Point Beach Nuclear Plant, Units 1 and 2
Dockets 50-266 and 50-301
Renewed License Nos. DPR-24 and DPR-27

License Amendment Request 261, Supplement 4
Extended Power Uprate

LICENSE AMENDMENT REQUEST 261, SUPPLEMENT 4 EXTENDED POWER UPRATE

Case 8-1: 2B-32 MCC Voltage Profile

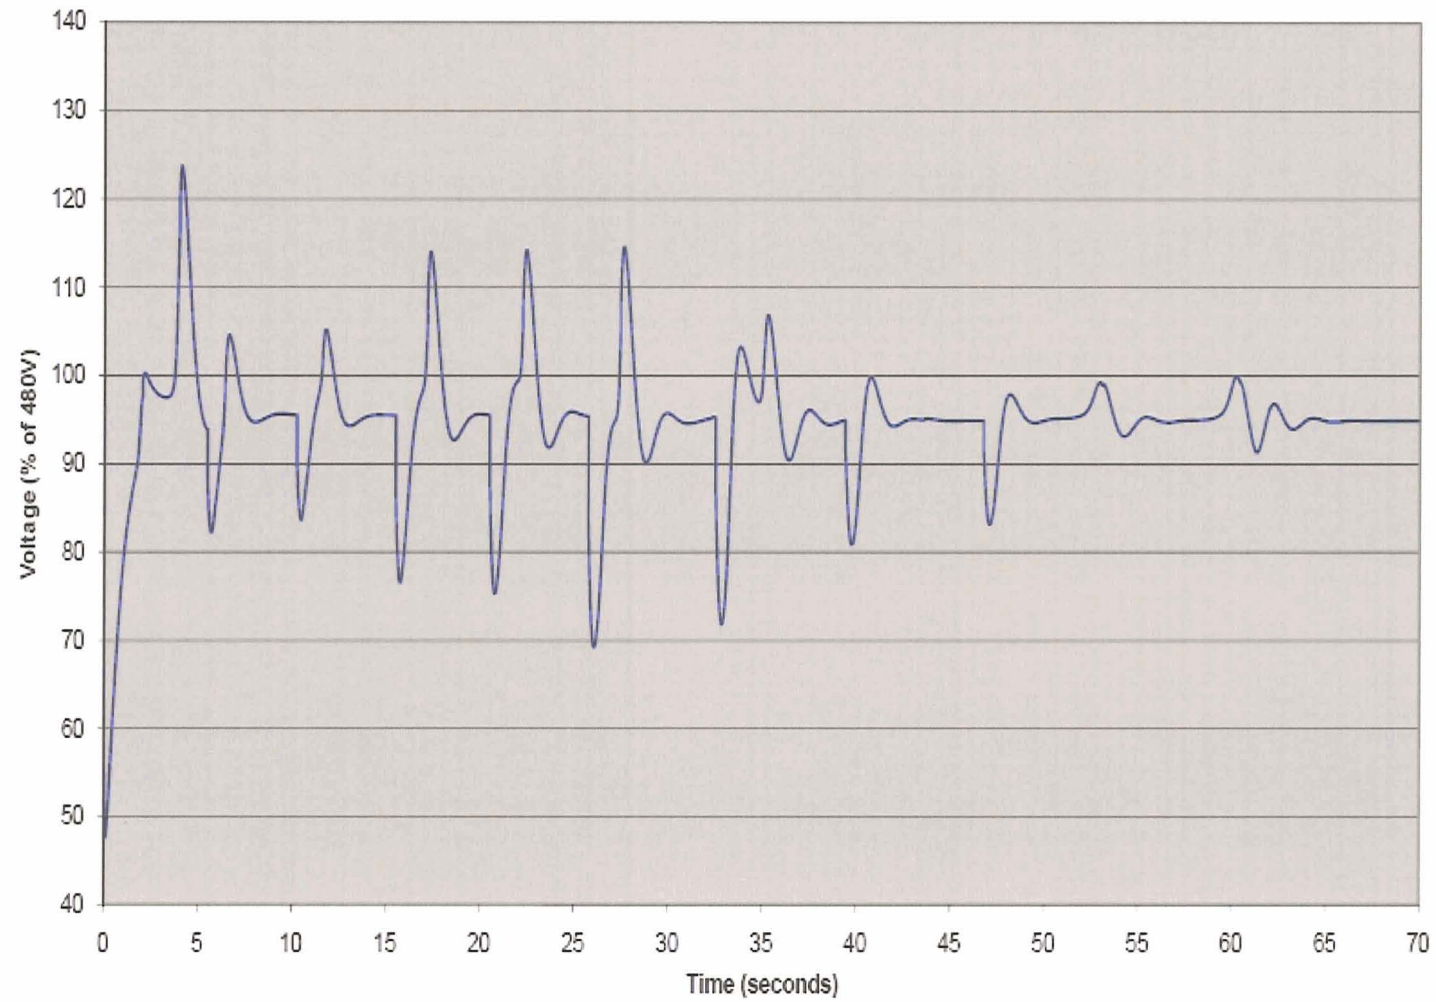
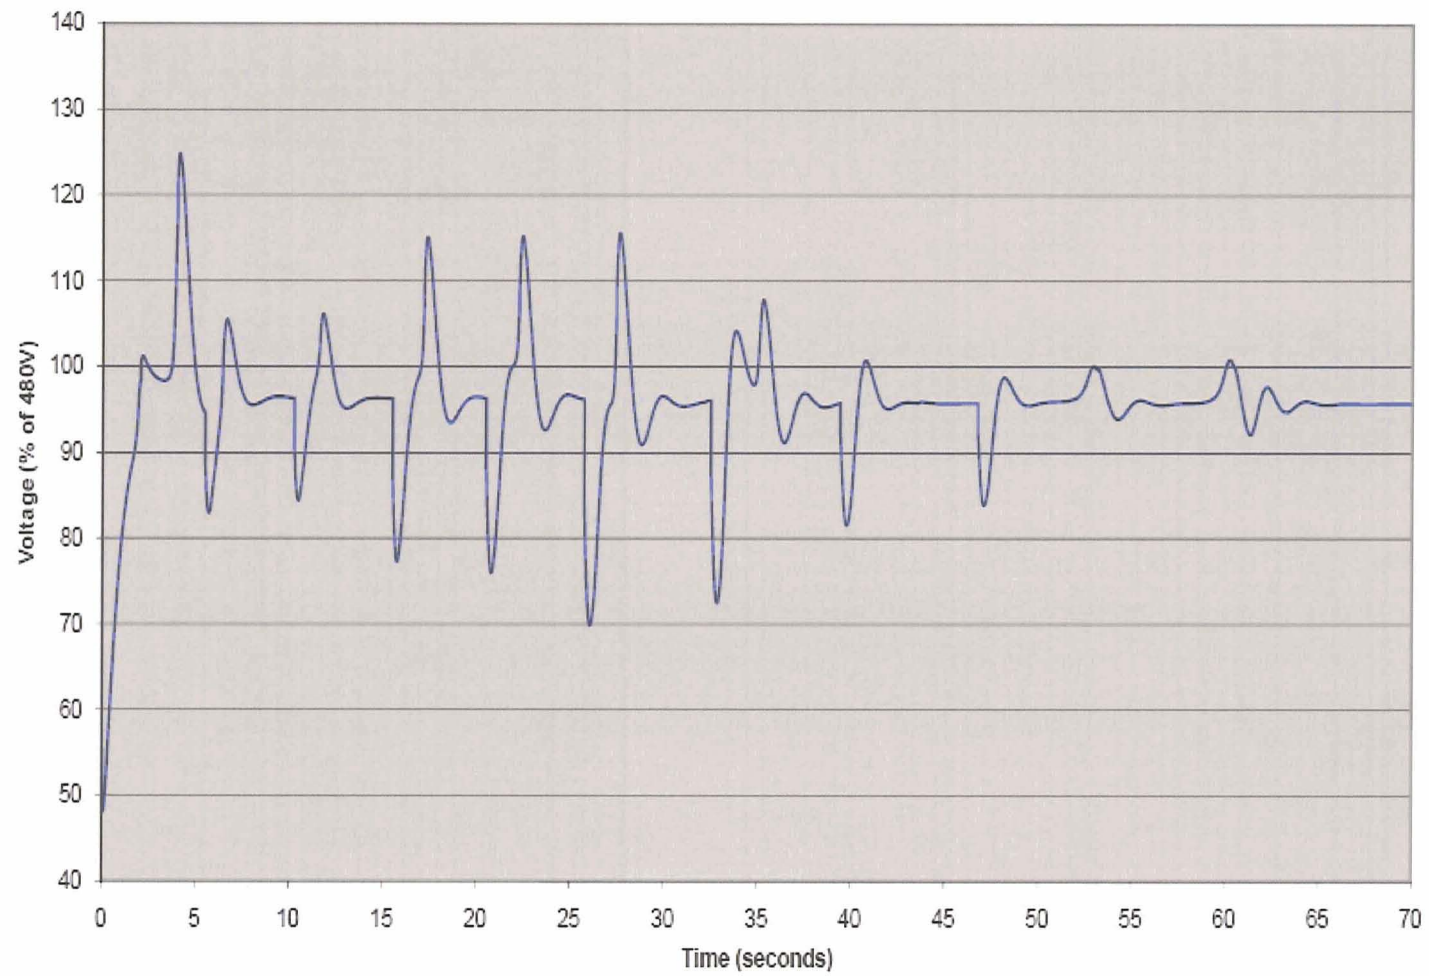
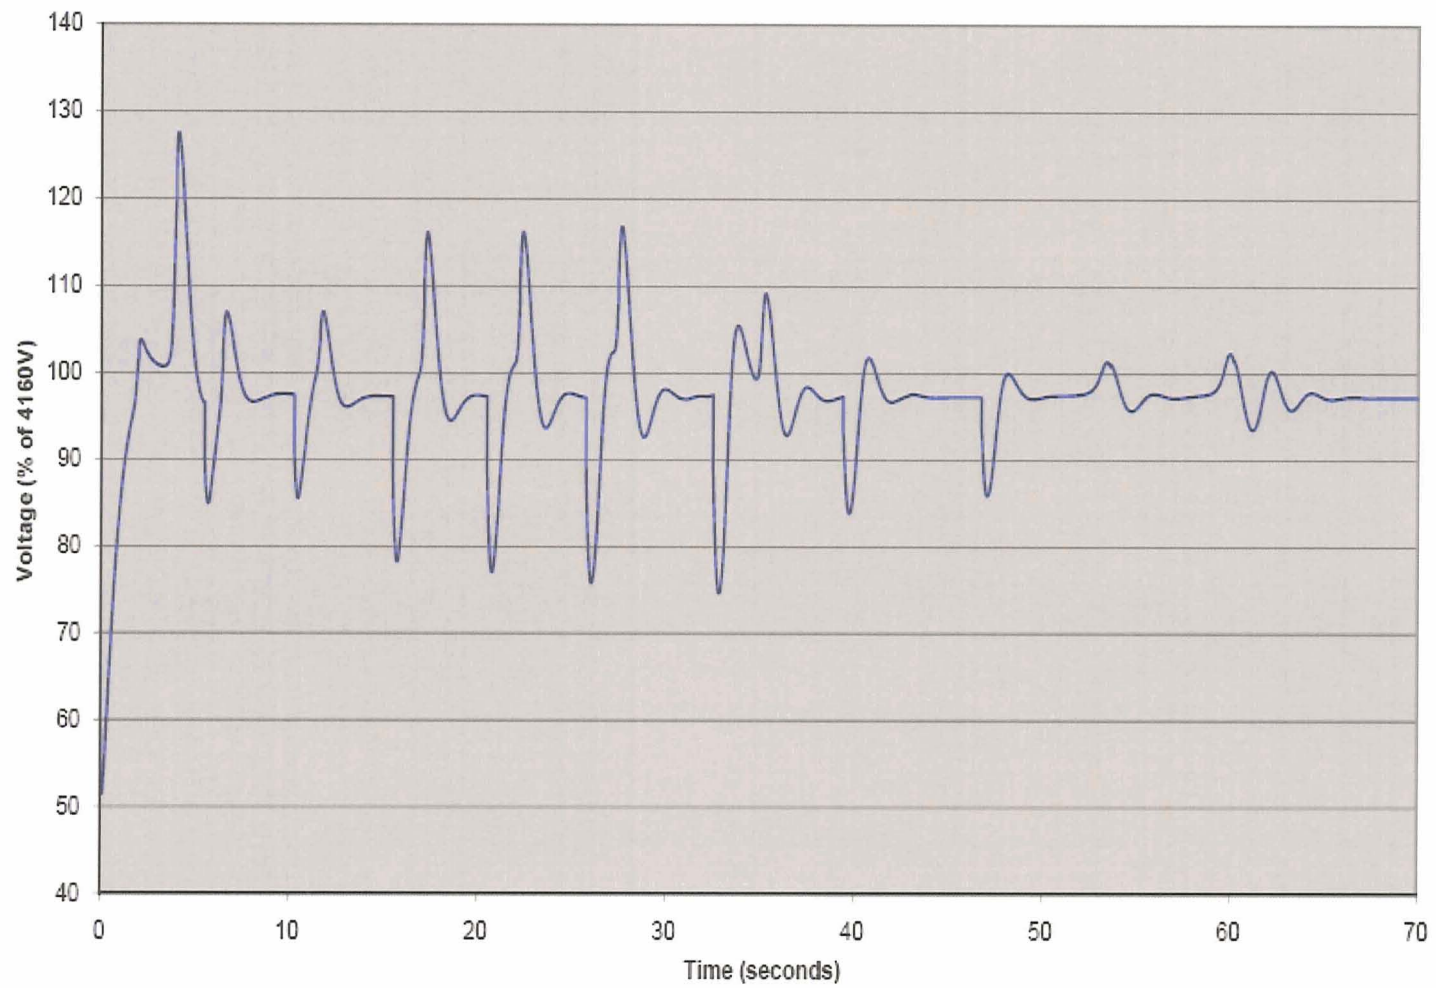
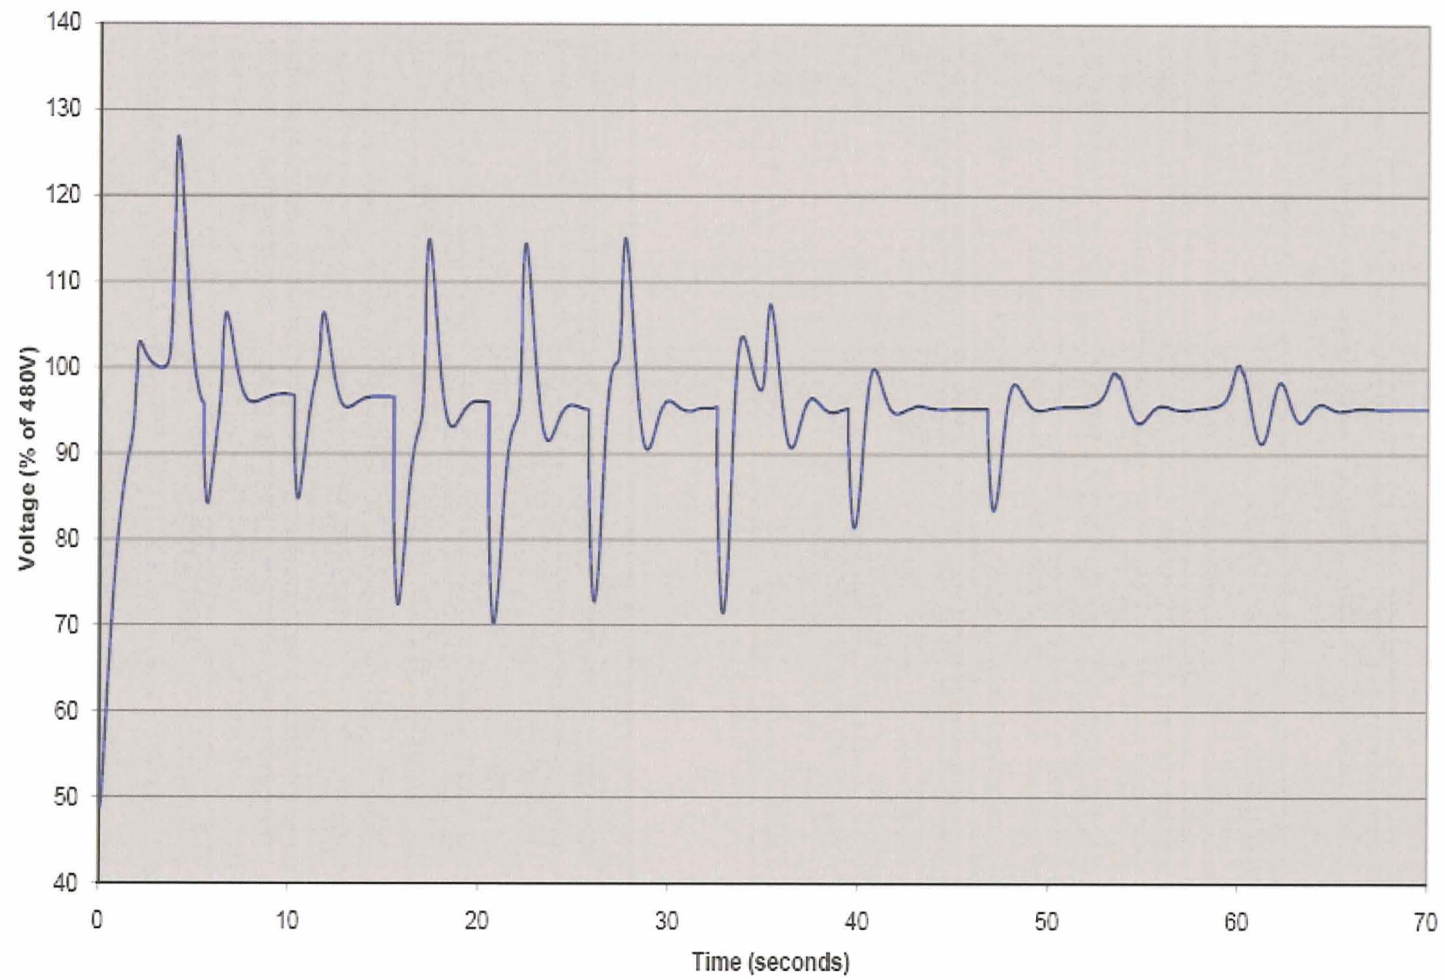
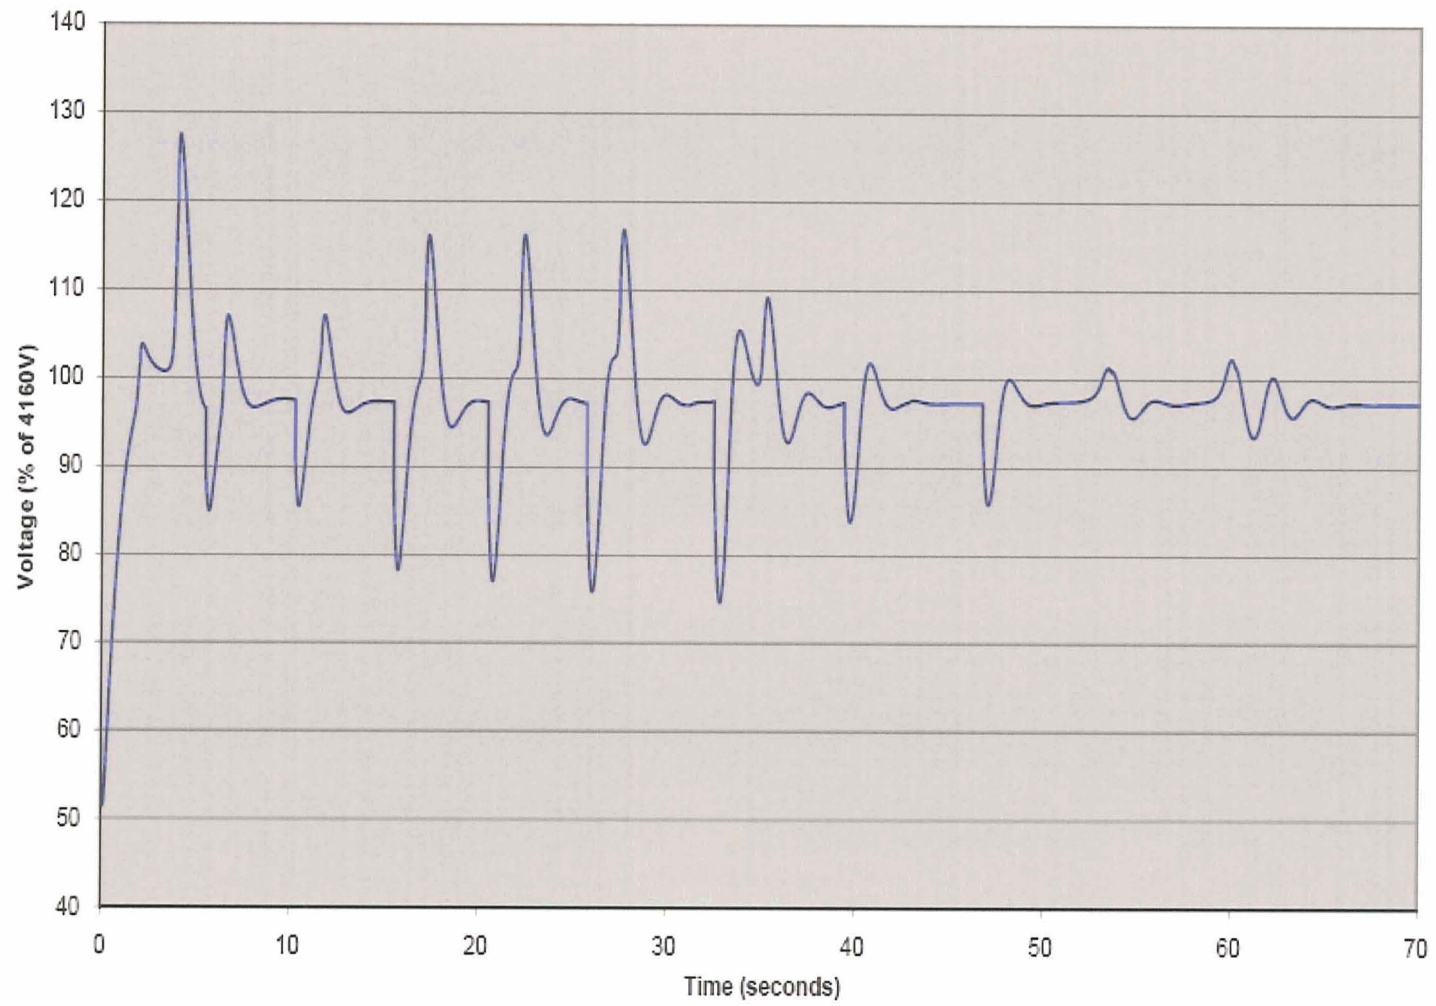
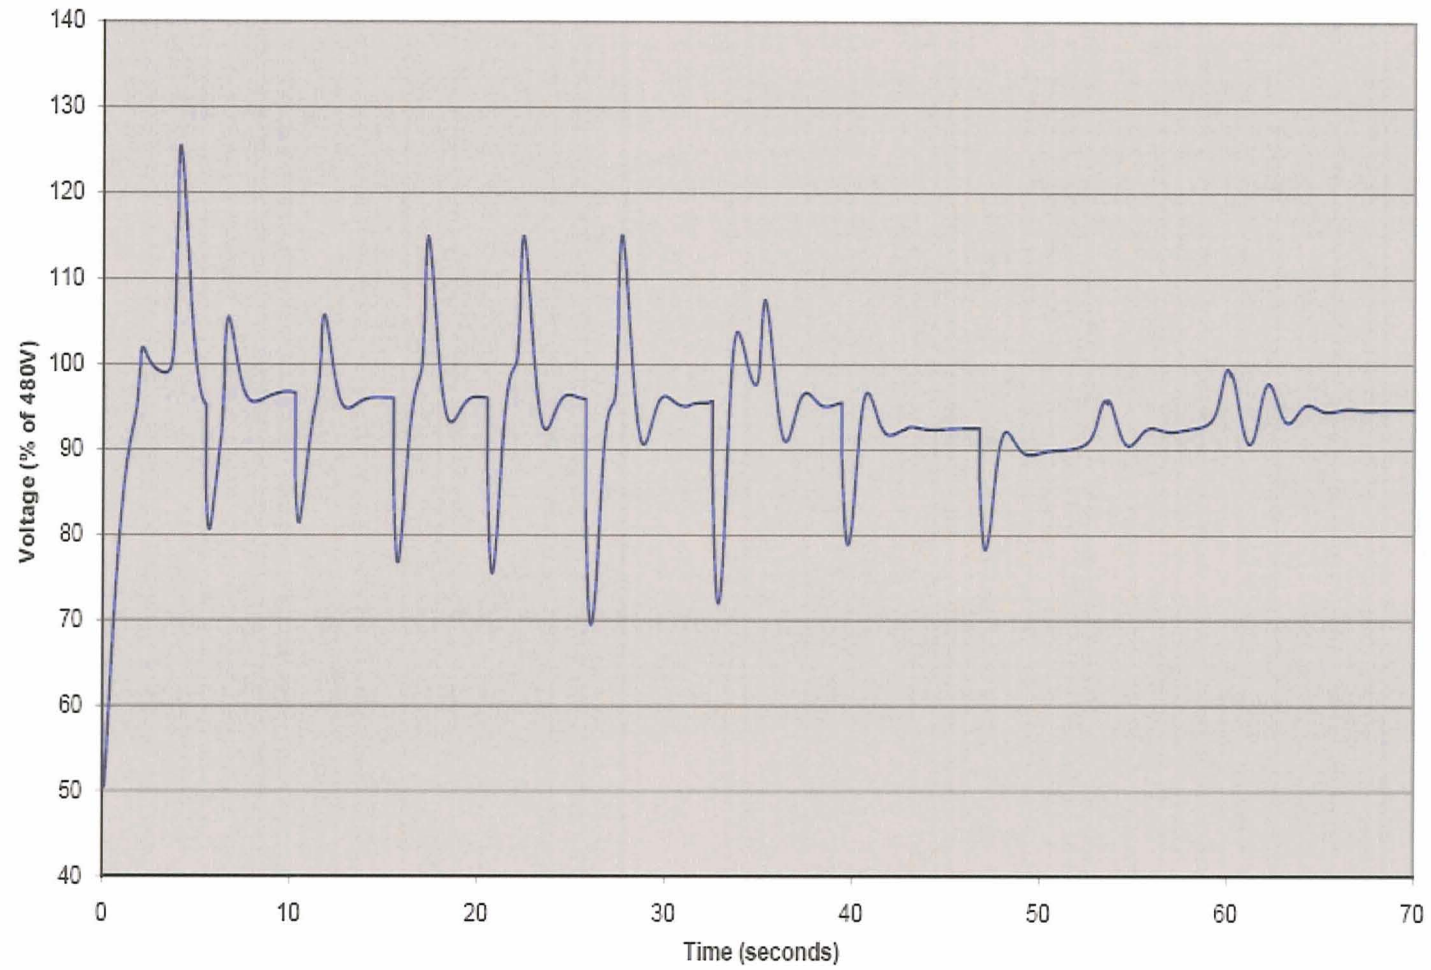
In response to staff's request for additional information (RAI) dated August 26, 2009, regarding the emergency diesel generator (EDG) voltage dip below the acceptance limit of 75 percent nominal voltage during motor start, the licensee stated that the EDGs are capable of starting safeguard loads, and the voltage recovers quickly to the acceptable level. Based on staff's review of the dynamic loading calculations, the staff notes that under certain loading conditions for Train "A" EDG, the frequency is outside 2 percent margin, the worst-case voltage dip is 45-48 percent and the voltage overshoot is 129.5 percent. Train "A" voltage and frequency variations are outside the industry accepted standards and guidance. Provide detailed analyses regarding the downstream effects on components such as contactors, control fuses, inverters, battery chargers, solenoids, motor-operated valves, solid state devices, etc., and the basis to show that all required loads will start and continue to run with sufficient margins after accounting for any uncertainties. Provide justification for the performance capabilities of the EDG "A" regulator and excitation systems to support shutdown equipment within design-basis requirements during a design-basis accident. The staff notes that Train "B" EDG bus voltages remain above 75 percent of nominal voltage, consistent with NRC Regulatory Guide (RG) 1.9, throughout the motor starting sequence in all postulated loading conditions. Provide a summary of all bus voltages for the 'B' train distribution system.

Attachment 3 provides a summary of bus voltages for the "B" train distribution system for the above large break LOCA design basis ETAP Cases.
